Staff Responses to Council Questions May 21, 2013

ComEd Road Lease Map

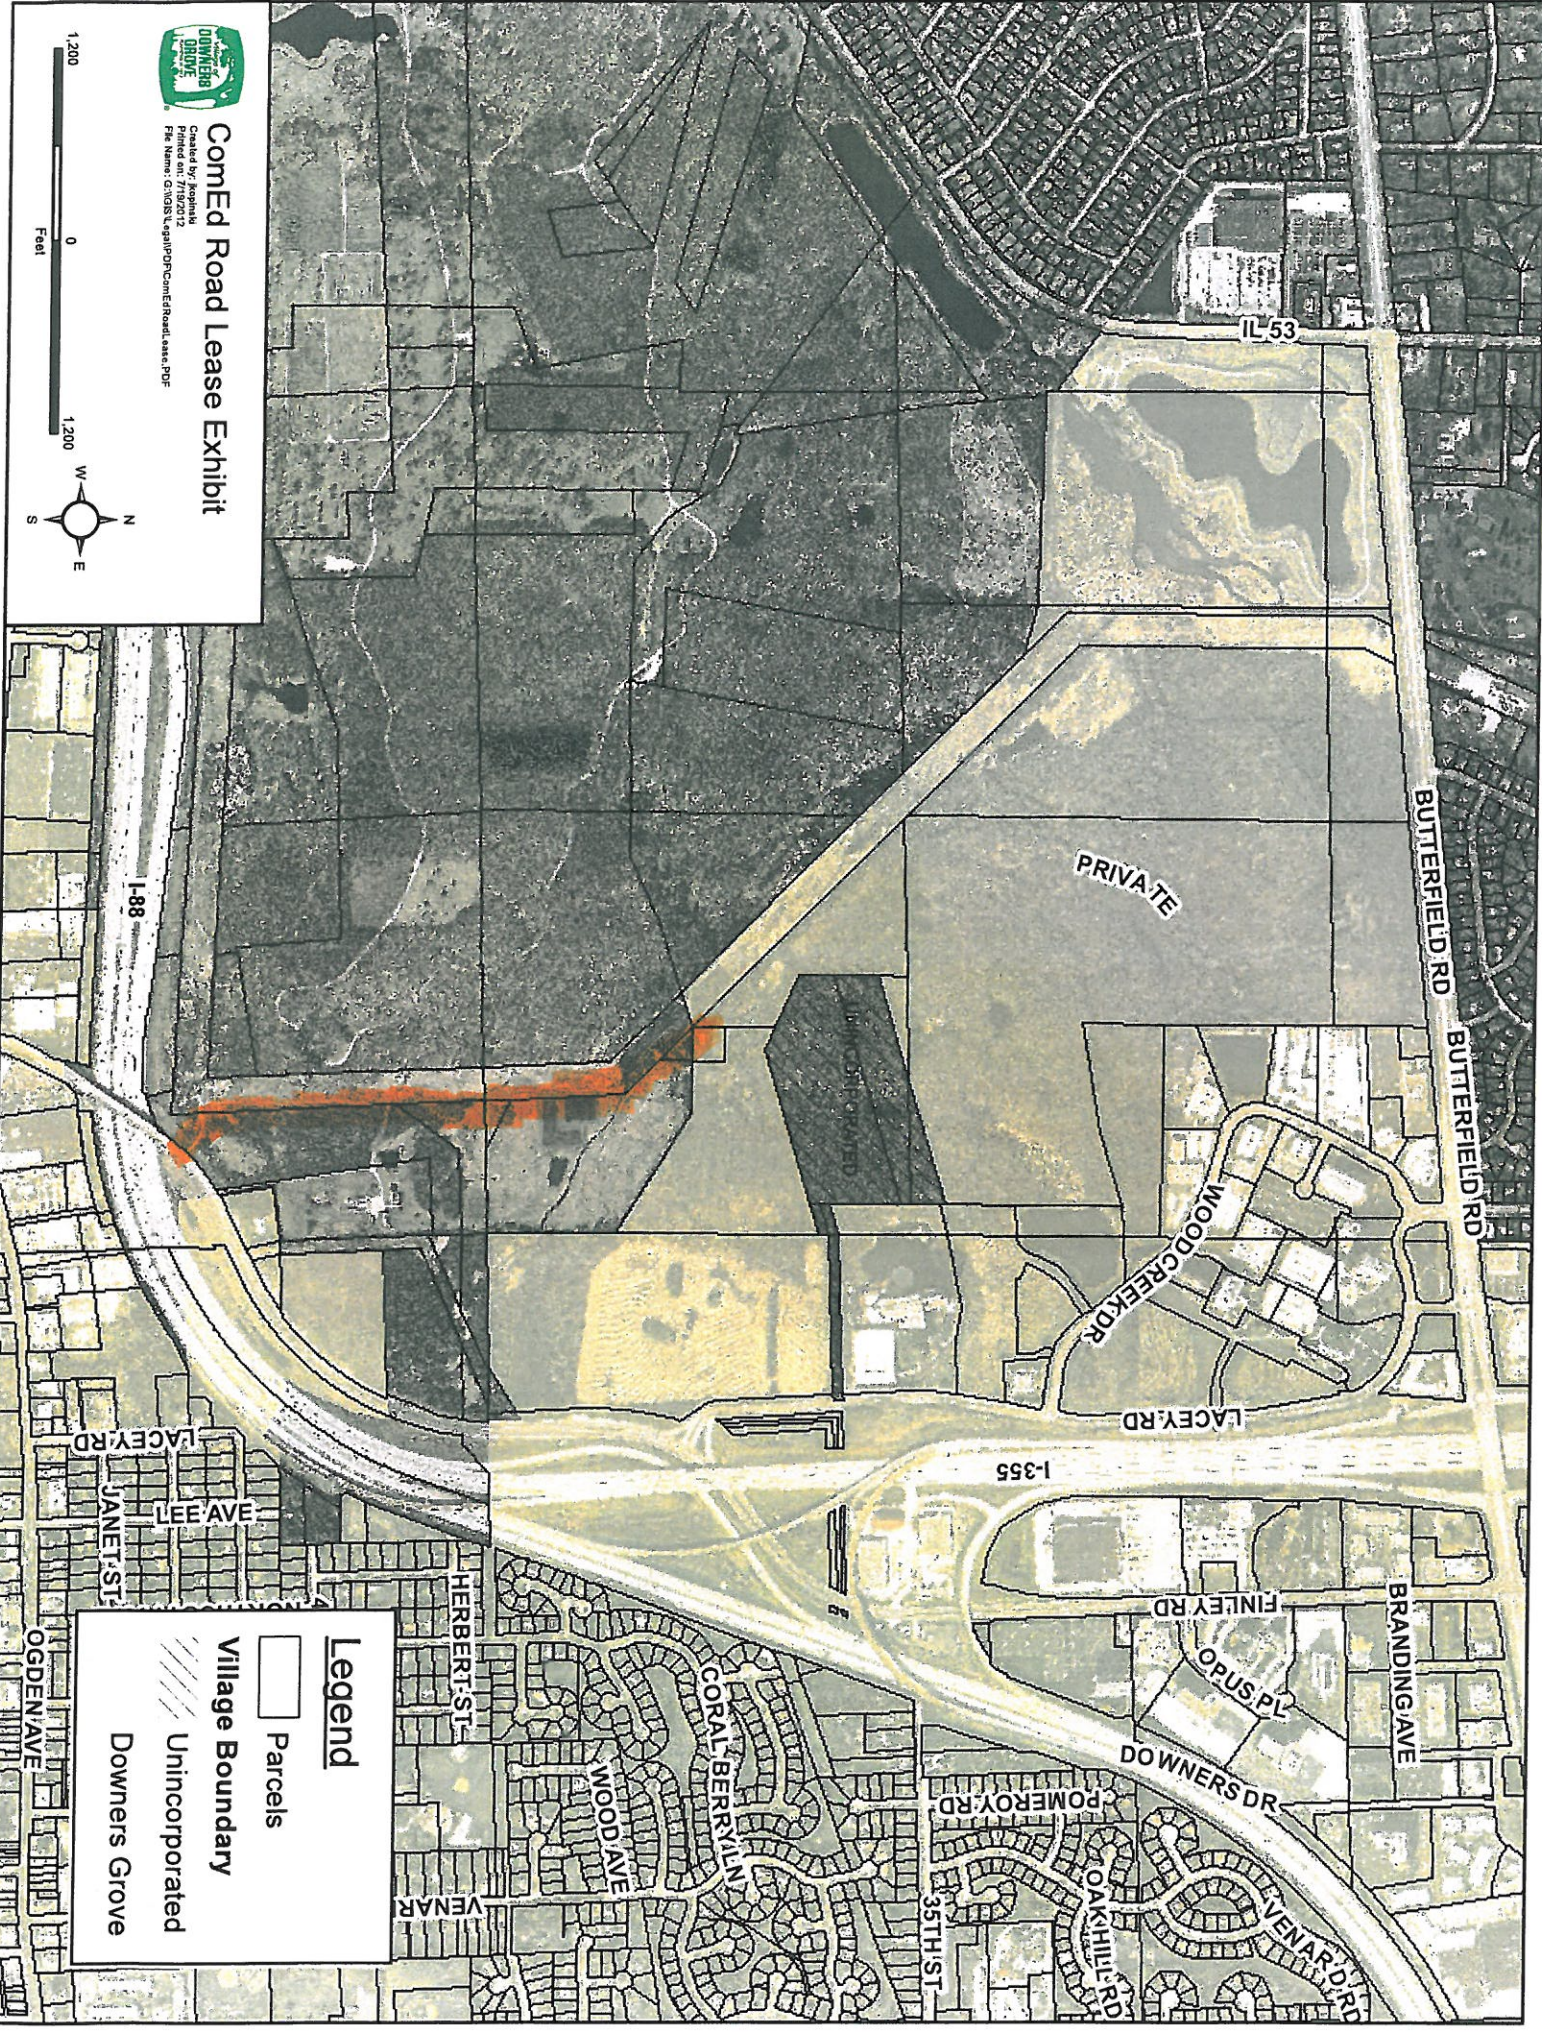
Com Ed Lease - Where is this property located?

The lift station is located north of I-88 and west of Finley. A map of the area in question has been attached.

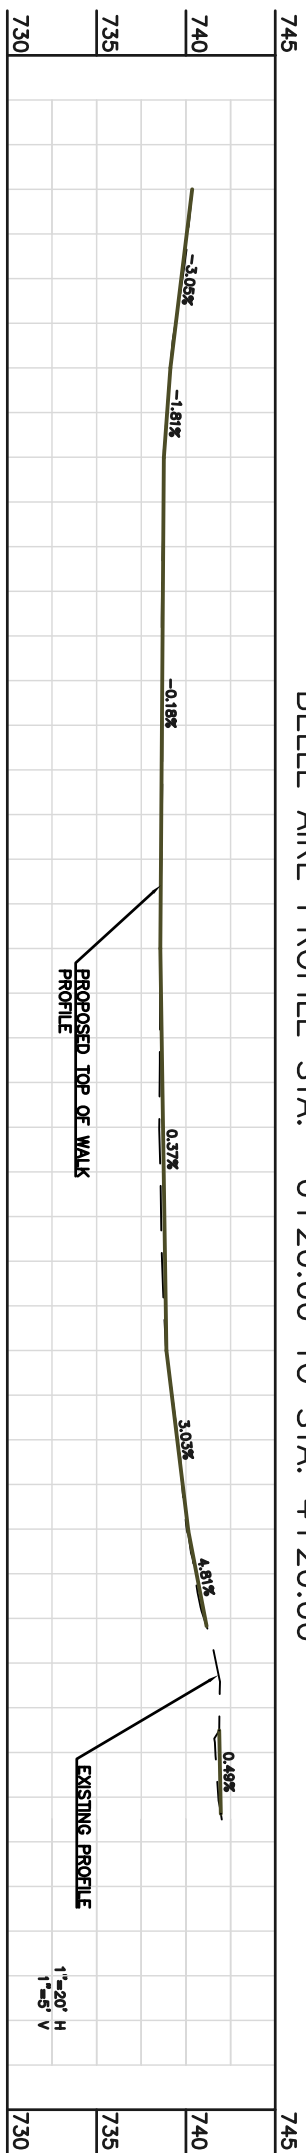
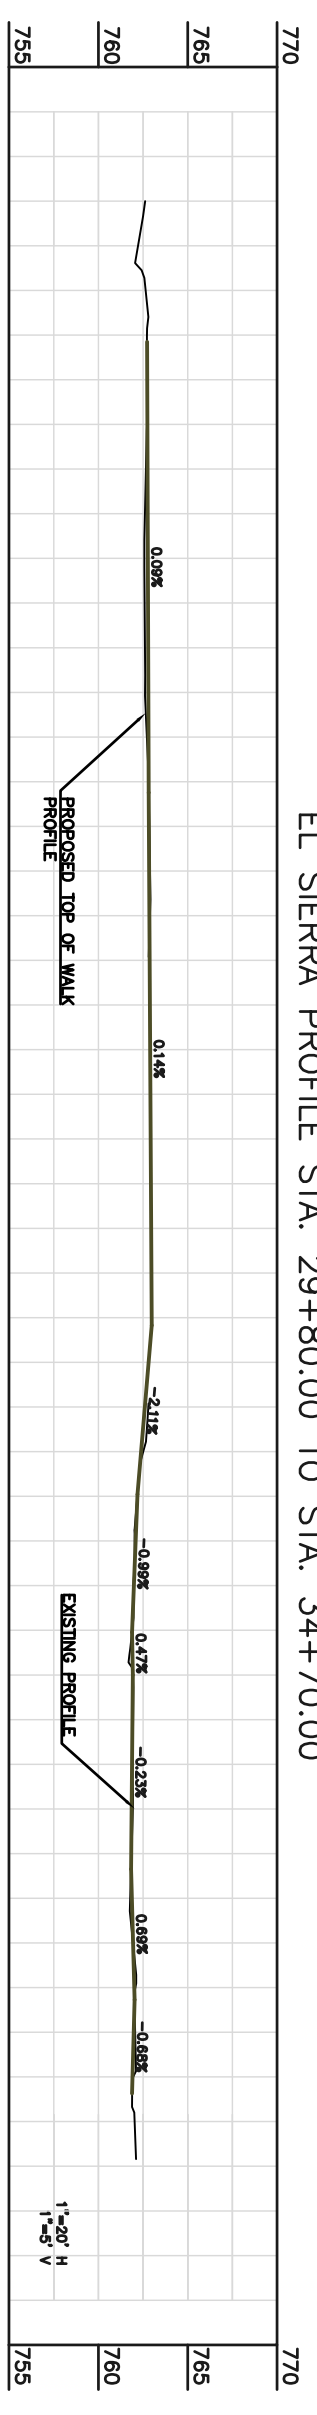
What is a pedway? Please describe the proposed pedways near El Sierra and Belle Aire.

The term refers to eight-foot wide asphalt paths, which were requested by the school district in these locations to make it easier to clear snow and to facilitate children walking and riding their bikes to school.

Exhibits showing the proposed locations of the paths at El Sierra and Belle Aire schools are attached. The exhibit for El Sierra school shows an alternate route which was recently requested by the school district and which we are reviewing with IDOT.
